PLANNING DIVISION STAFF REPORT August 8, 2016 PC and September 9, 2016 CC

Project Address: 412-414 S. Baldwin St. (District 6 - Ald. Rummel)

Application Type: Zoning Map Amendment, Conditional Use

Legistar File ID # [43695](#) and [43417](#)

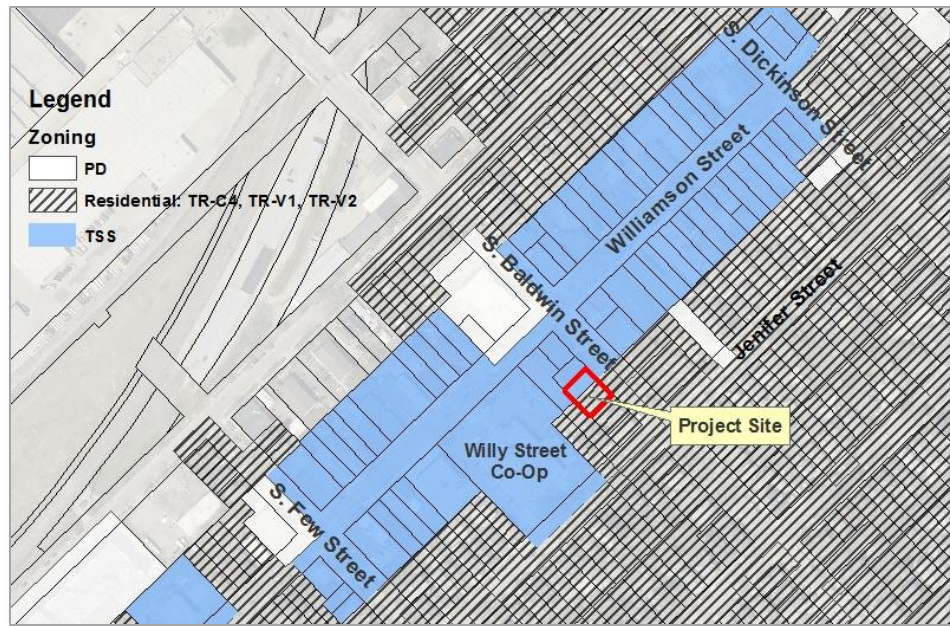
The proposed building addition is comprised of four stories and 6,880 square feet. The ground floor is the proposed location of the proposed restaurant-tavern and includes pedestrian oriented design elements, including storefront windows. The upper two stories will be comprised of eight hotel rooms. The front façade of the building is clad in brick that wraps around either corner, where composite siding begins and continues along the rear building elevation. The proposed building addition is minimalistic in detailing, including stone window sills and lintels and stone block accents.

- The mass and scale of the proposed building is consistent with that of the surrounding development, which are primarily two-three stories in height. Although the proposed building addition is considered a four-story building as a result of the stair tower overrun, it will read as a three-story building. The stair tower comprising the fourth story, which necessitates the building height Conditional Use request, is minimalistic and will provide the access required by the building code to the rooftop deck, an on-site open space amenity, and is not a full story;

- The proposed building material palette is comprised primarily of brick (on the front façade, wrapping to the side elevations) and vinyl siding (on the side and rear facades). Both are materials that are present in the surrounding neighborhood; and

- The proposed building design and architectural treatment is reflective of commercial structures of its time (circa 1900). Given the location of the project site within the Third Lake Ridge Historic District, warrants additional design consideration to creating a modern building of its time, but that is also reflective of the districts time period. Planning Division staff believes that the requested building side yard stepback exception meets the applicable approval standards to provide architecture that is consistent and compatible with, and respectful of the standards for the historic district.
